AA-F-363D
AMENDMENT 4
APRIL 6, 2015
SUPERSEDING
AMENDMENT 3
APRIL 20, 2007

FEDERAL SPECIFICATION

FILING CABINET, SECURITY, MAPS AND PLANS, GENERAL FILING AND STORAGE

Figure I
Schematic arrangement of lock case holes.

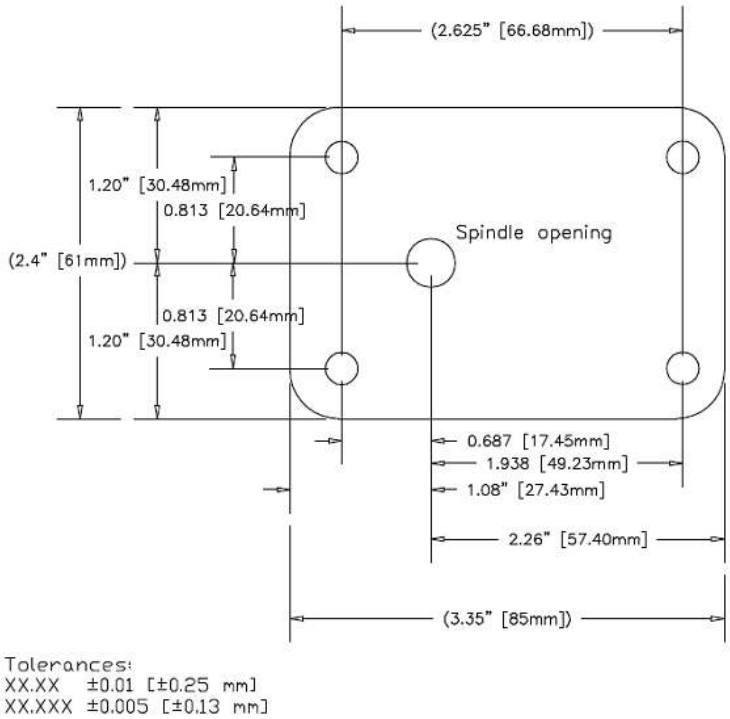
3.4.3.3 Lock mounting plate. A ¼” thick combination lock mounting plate drilled and tapped for four (4) ¼-20 mounting holes (through the plate as in figure I) and with a 3/8” spindle hole for the combination lock shall be welded to the inside of the lock box. The lock mounting surface of the lock mounting plate shall have a flatness tolerance of 0.003 inch per inch.

Add the following figure:
